RESOLUTION NO. PC22-040

A RESOLUTION OF THE PLANNING COMMISSION OF THE CITY OF ONTARIO, CALIFORNIA, RECOMMENDING THE CITY COUNCIL CERTIFY THE PROGRAM SUPPLEMENTAL ENVIRONMENTAL IMPACT REPORT (STATE CLEARINGHOUSE NO. 2021070364) FOR THE ONTARIO PLAN 2050 TECHNICAL UPDATE FOR FILE NO. PGPA20-002 PART A AND ADOPT ENVIRONMENTAL FINDINGS PURSUANT TO THE CALIFORNIA ENVIRONMENTAL QUALITY ACT, A STATEMENT OF OVERRIDING CONSIDERATIONS AND A MITIGATION MONITORING AND REPORTING PROGRAM.

WHEREAS, the Supplemental Environmental Impact Report (“SEIR”), for the General Plan Amendment for The Ontario Plan 2050 Technical Update consists of the Draft SEIR and the comments and responses to comments made on the Draft SEIR; and

Figure 5.19-4

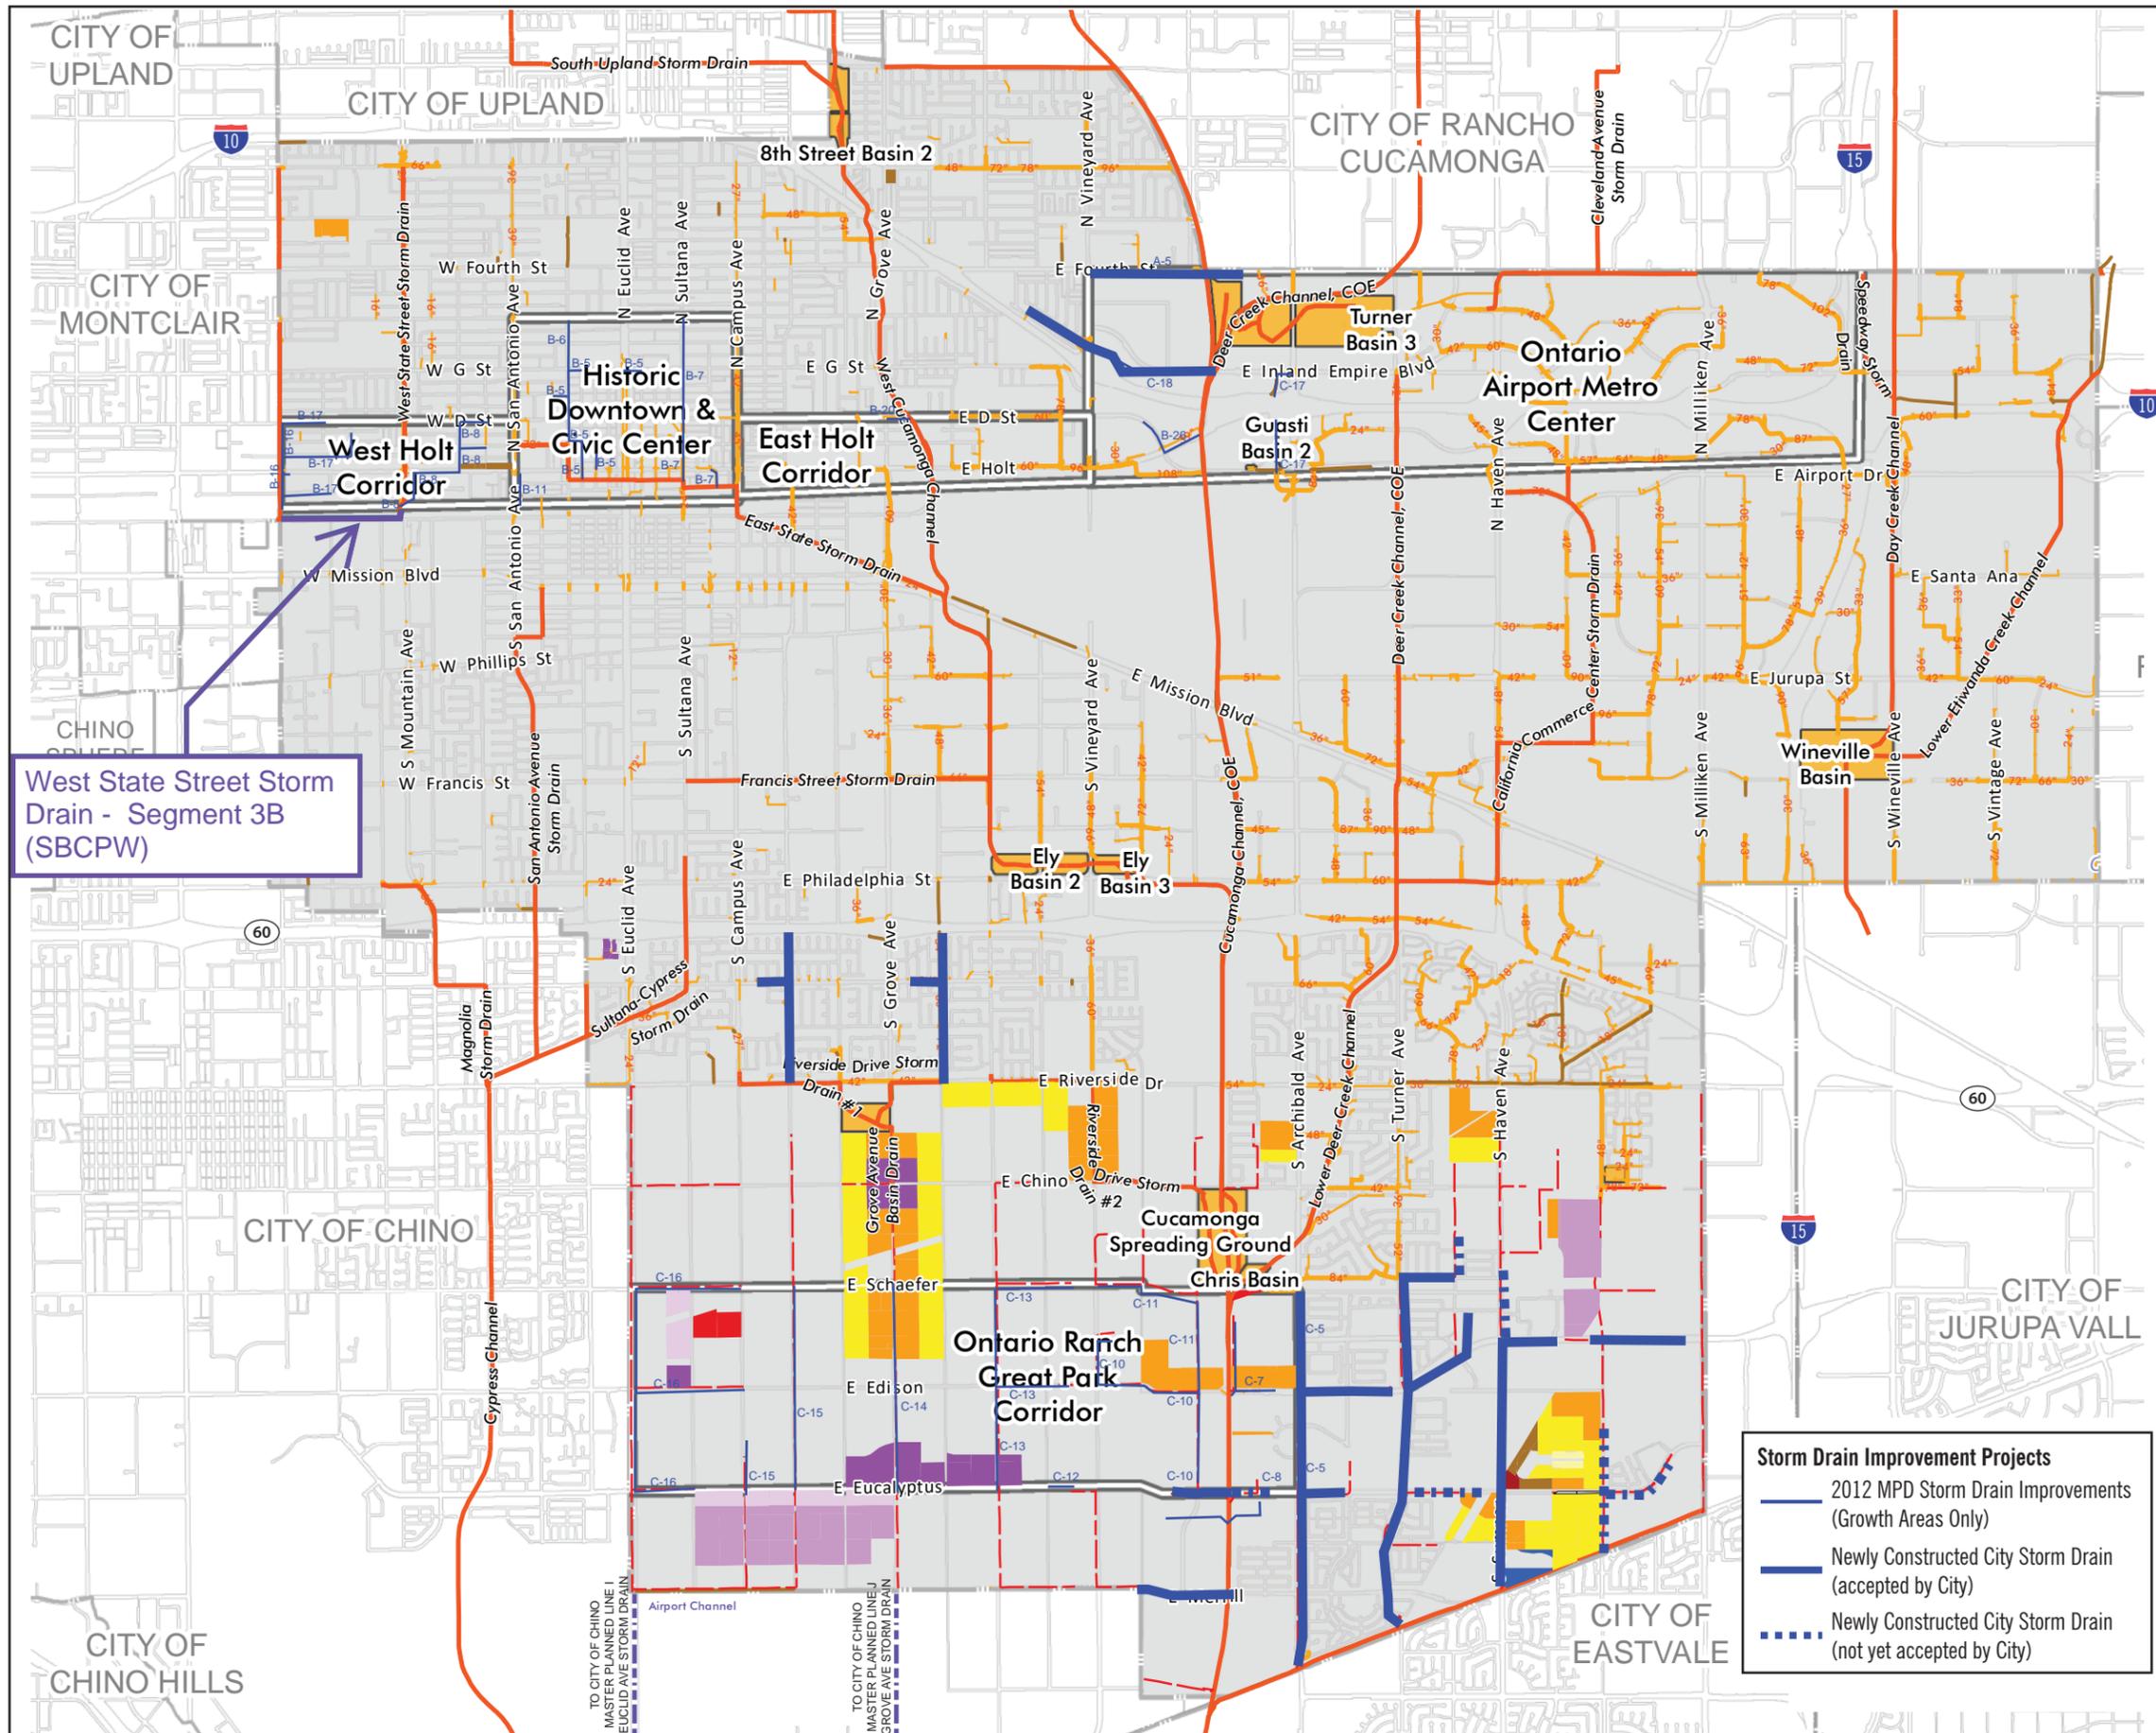
1. Figures 5.19-4 and Figure 7 (Infrastructure Report) are not consistent with the City of Chino's Master Plan of Drainage and should be updated. Both figures depict a SB County Flood Control Channel on Euclid south of Merrill rather than a proposed storm drain per the City's Master Plan. Intro

A2-1 At the request of the Commenter, the symbology on Figure 5.19-4 has been revised to show the City of Chino proposed storm drain (see Chapter 3, *Revisions to the Draft EIR*, and Appendix A, *Revised Draft SEIR Figures*).
